SOLACE AT CIMARRON HILLS
— FILING NO. 1
SITE AND OVERALL UTILITY PLAN

SOLACE AT CIMARRON HILLS

SITUATED IN THE NORTHWEST QUARTER OF SECTION 7
TOWNSHIP 14 SOUTH, RANGE 65 WEST OF THE SIXTH PRINCIPAL MERIDIAN
COUNTY OF EL PASO, STATE OF COLORADO
SANITARY SEWER PLAN AND PROFILE

WATER DISTRIBUTION PLAN

SHEET 3 OF 32
JOB NO. 25174.00

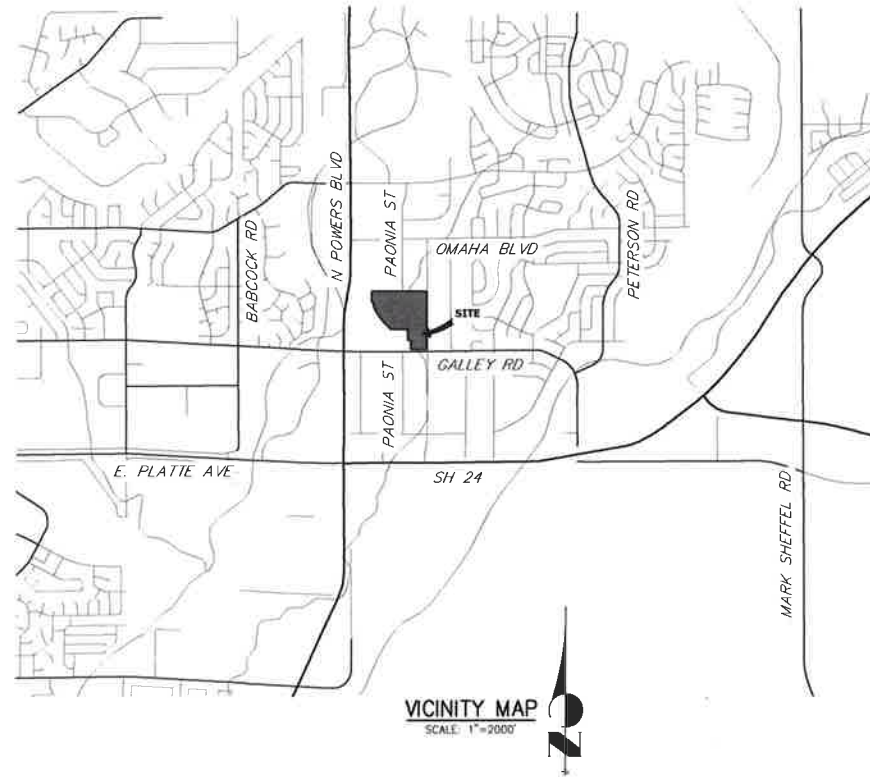
*REPLACE W/ SHEET 4 OF 28 INCLUDED
IN EDAPP ATTACHMENT "SITE DEVELOPMENT PLAN"*

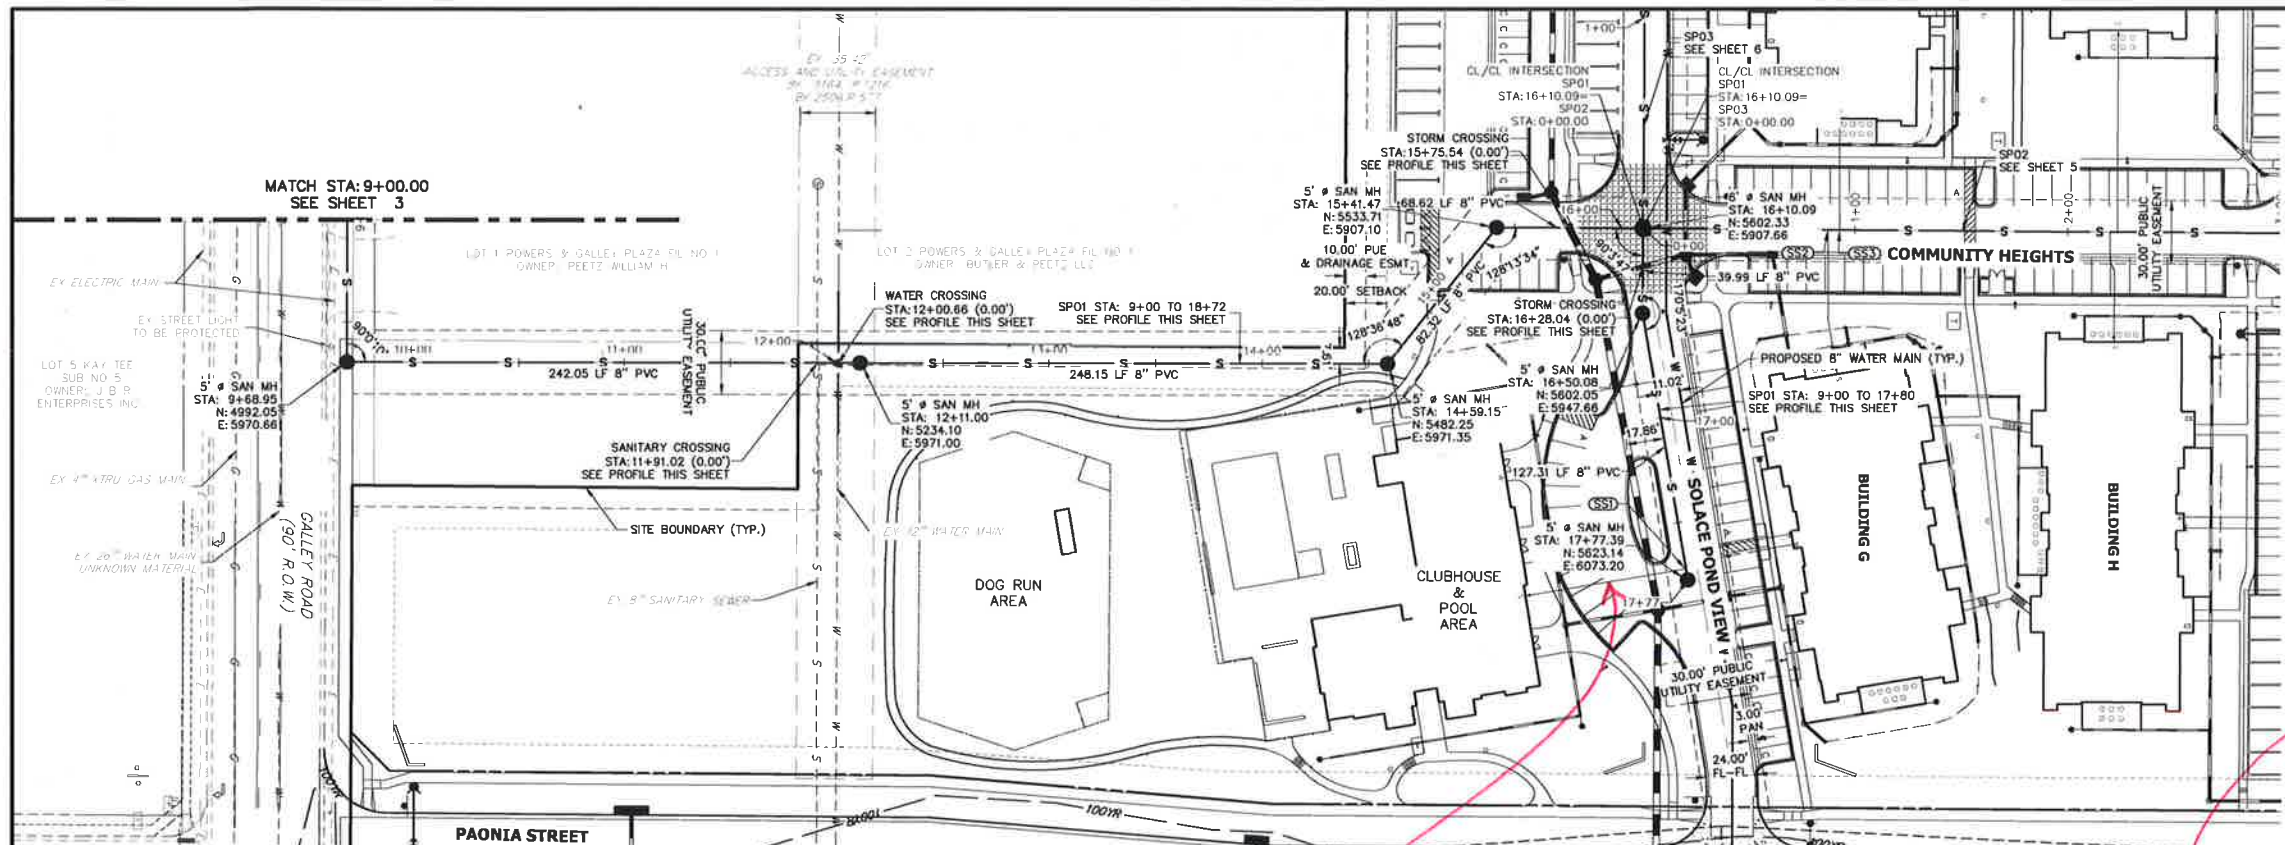
REPLACE WITH SIGNED SHEET

**SP01 PROFILE (2)
STA 9+00.00 TO 17+80.00**

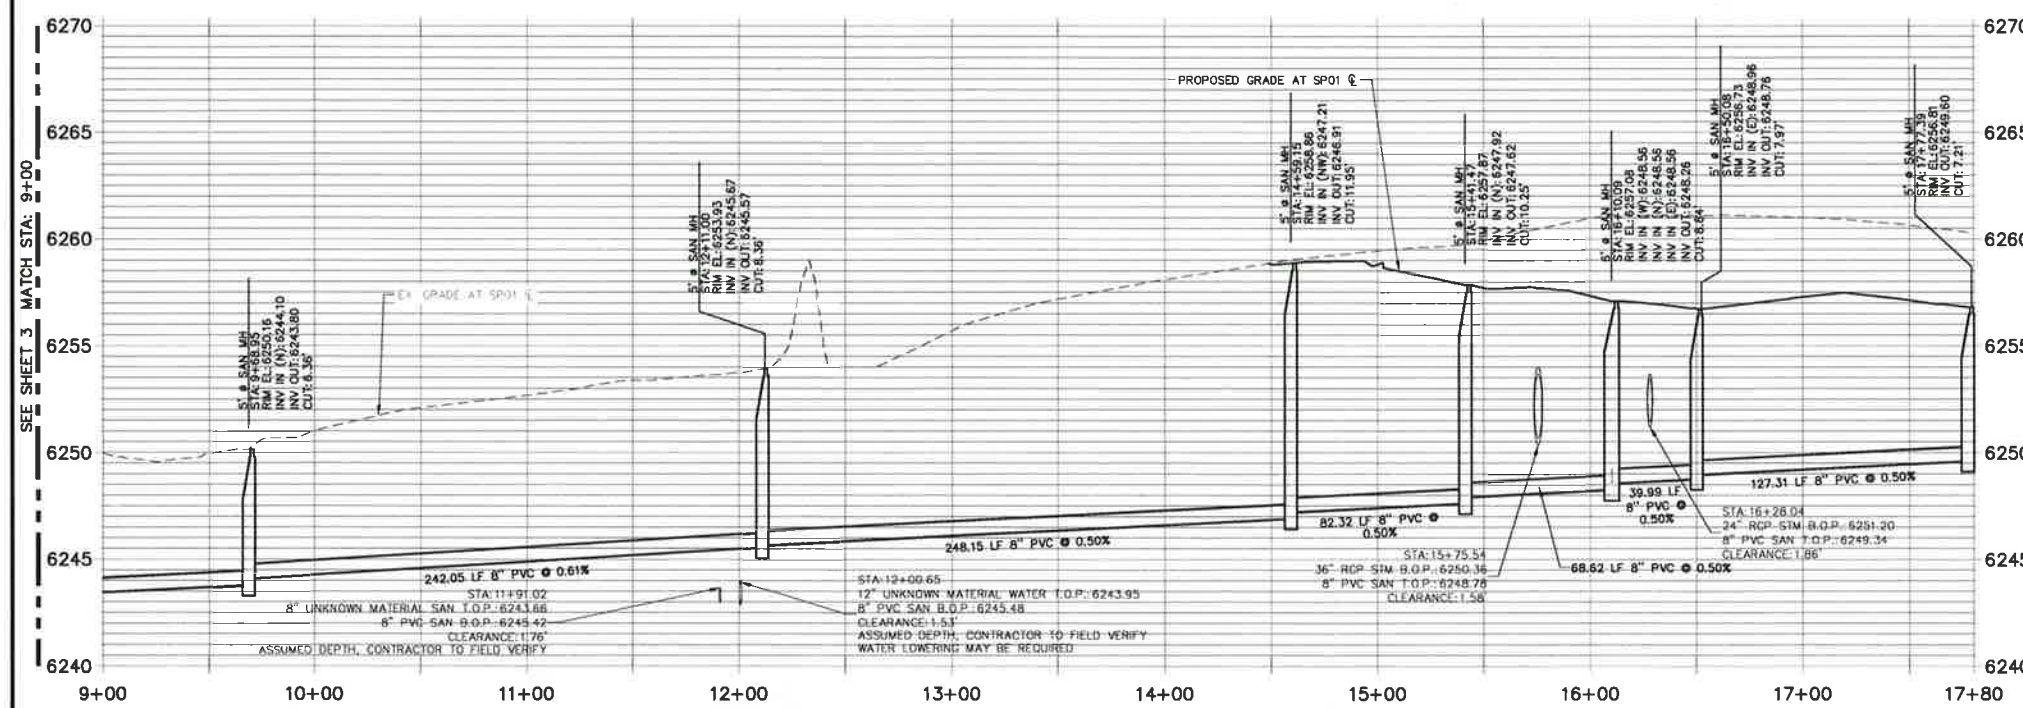
ADD NOTES 182 FROM SHEET 4 & 5 OF 28 SITE DEV. PLAN SET FOR PUBLIC SANITARY SEWER SYSTEM TYP ALL SHEETS

LABEL SERVICE LINES & PROVIDE CLEAN OUT ON SERVICE LINE SEE CS4 STD D1-4 TYP ALL PLAN & PROFILE SHEETS

PROVIDE MATERIAL & SIZE

**WL-8 PROFILE
STA 0+00.00 TO 6+65.00**

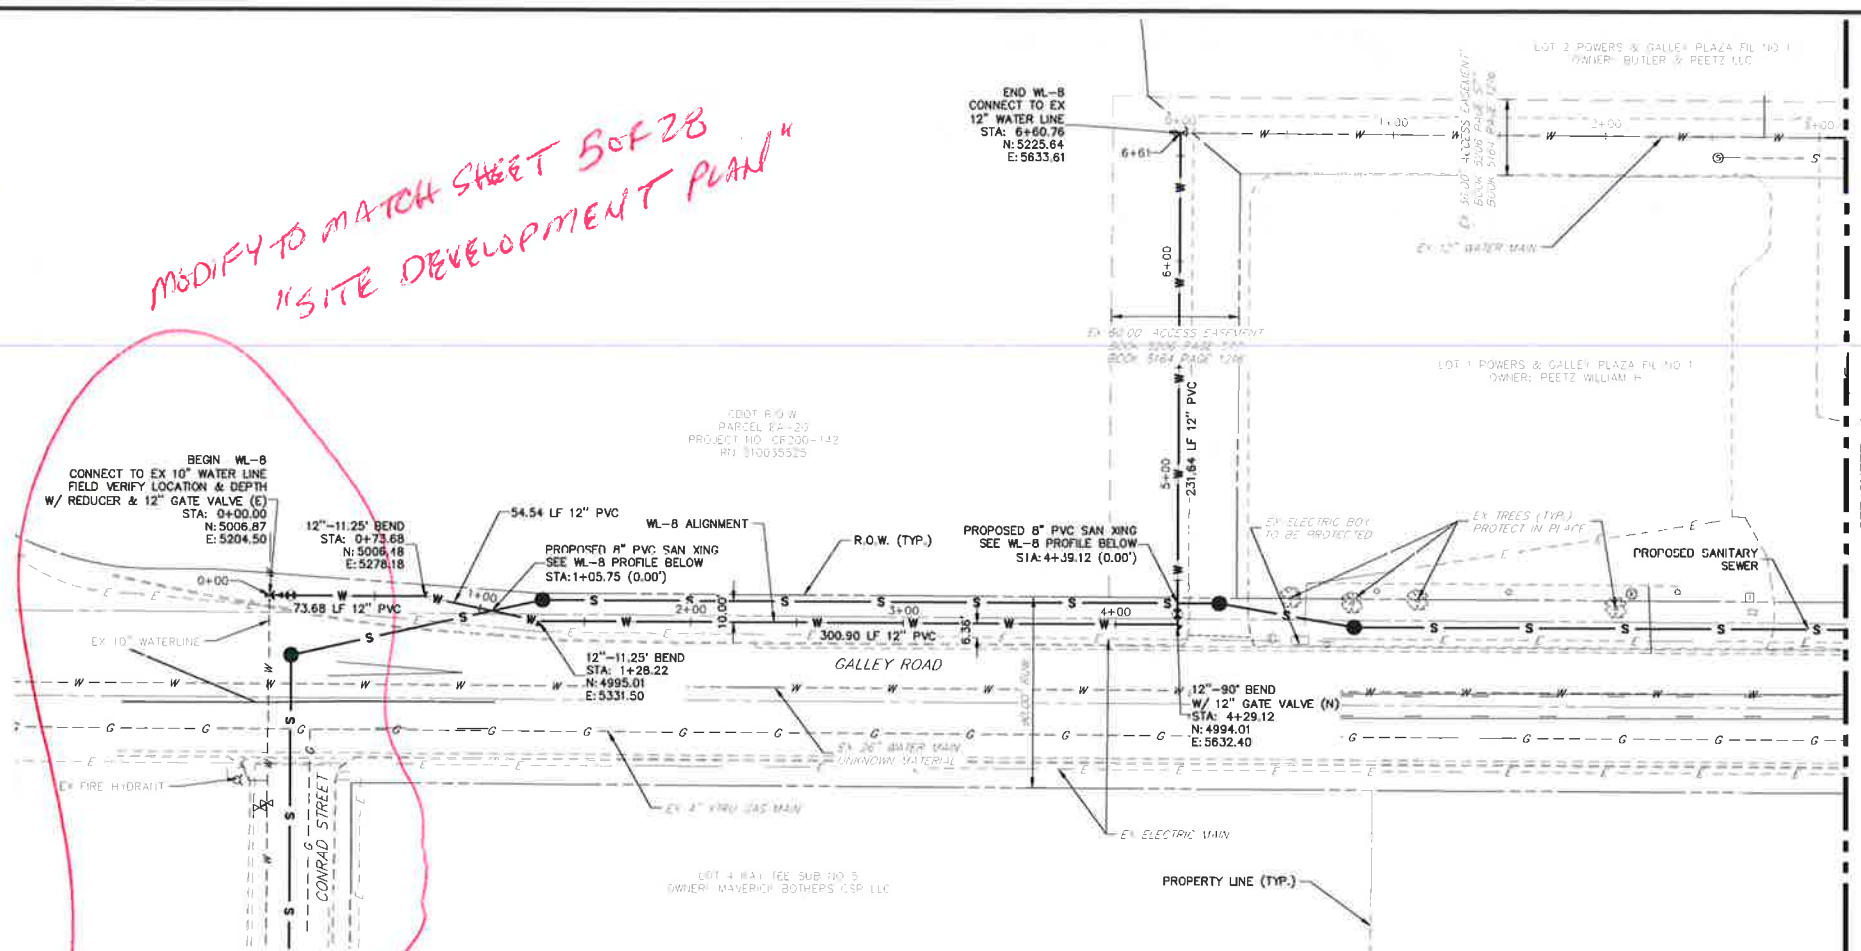
*MODIFY TO MATCH SHEET 5 OF 28
"SITE DEVELOPMENT PLAN"*

*REPLACE CMD STD REFERENCES
W/ CSU STDS. TYP ALL SHEETS*

*ADD NOTES ON SITE DEVELOPMENT PLAN SHEETS 4 & 5 OF 28 (NOTES 1 & 2)
TYP ALL SHEETS*

SHEET 5 OF 10
 JOB NO. 25174.00

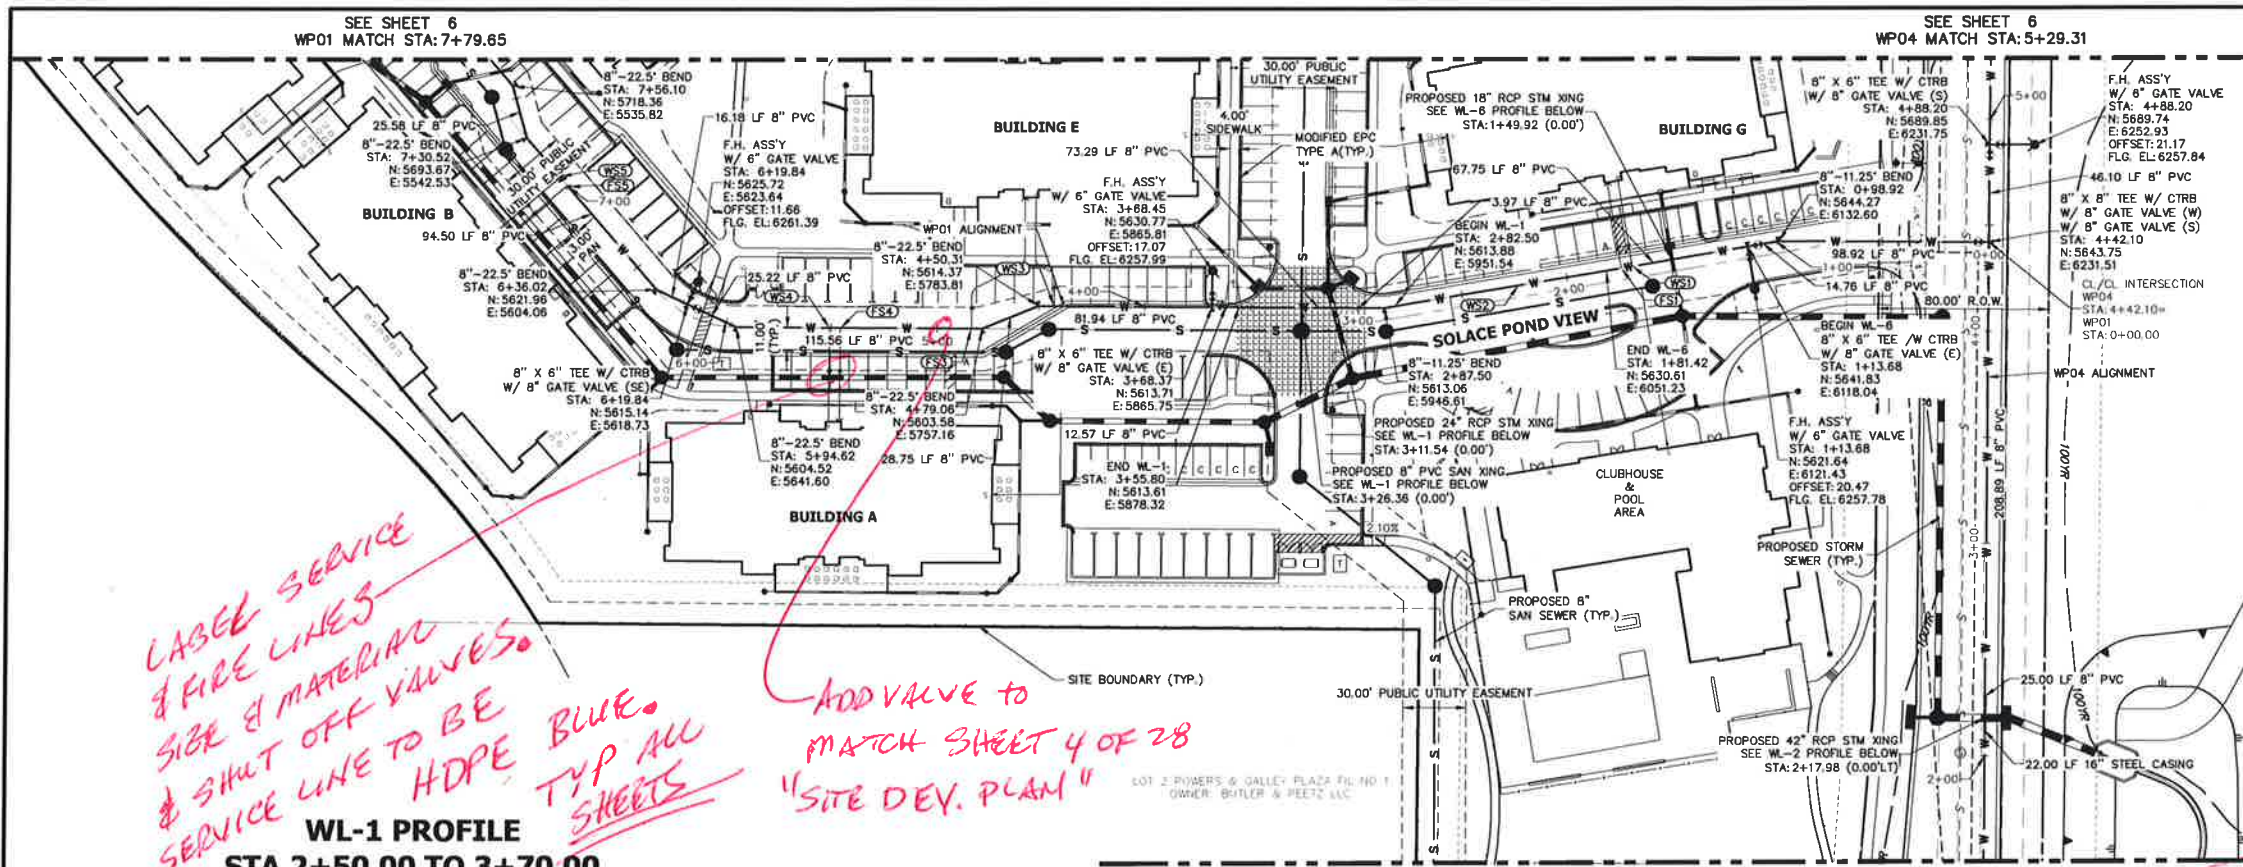
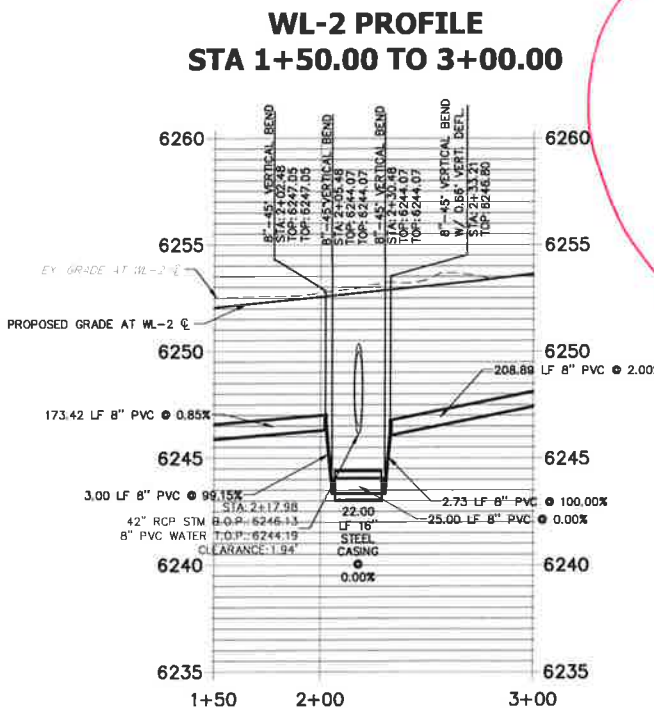
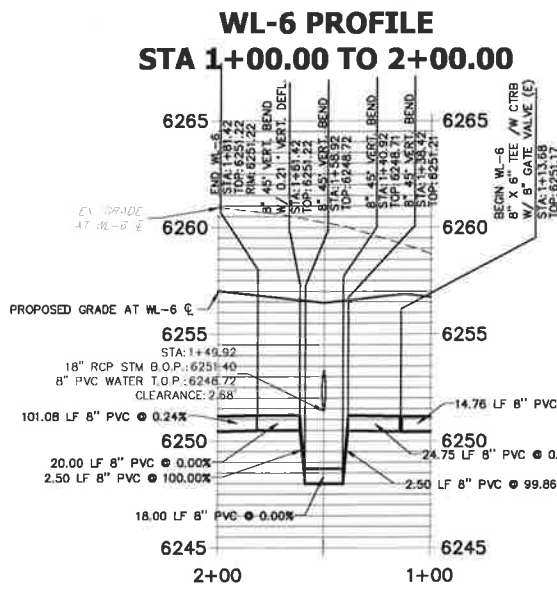
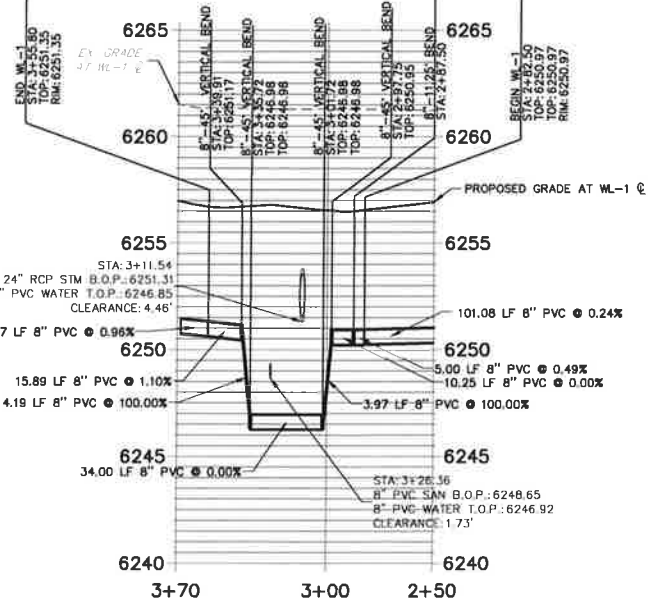
LABEL SERVICE & FIRE LINES SIZE & MATERIAL & SHUT OFF VALVES. SERVICE LINE TO BE HDPE BLUE. TYP ALL SHEETS

ADD VALVE TO MATCH SHEET 4 OF 28 "SITE DEV. PLAN"

REPLACE CMD REF STD'S W/ CS & STD'S.
